GTS NEWSLETTER

TASKI ergodisc 165/200/300/400/Duo assembly drive

Brush housing compl.

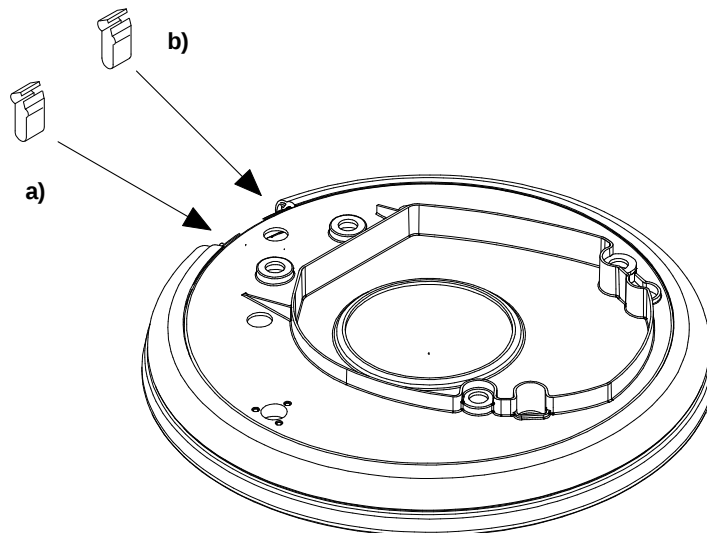
By storage the ergodisc in upright position for a longer period and without pad-drive or brush, the brush housing sinistral gets minor deformations.

To avoid this, a second supporting clamp b) is mounted and exonerates the safety protection shield.

These is a complementary measure to the center plug (see TCS Info 2001/02)

- o All deliveries ex. Münchwilen will be with the new design order No. 4122576 (14604-33) with 2 clamps
- o As spare part is still the supporting clamp set 4117460 (14604-19) available
- o The design change doesn't allow to retrofit old brush housings with a second clamp. The complete brush housing has to be changed
- o TASKI ergodisc range Ø38 and Ø50 will remain as they are

TASKI ergodisc Ø 43 with reinforced brush housing

from machine No. 18242

Since mid of August 2004, only reinforced brush housings will be delivered.
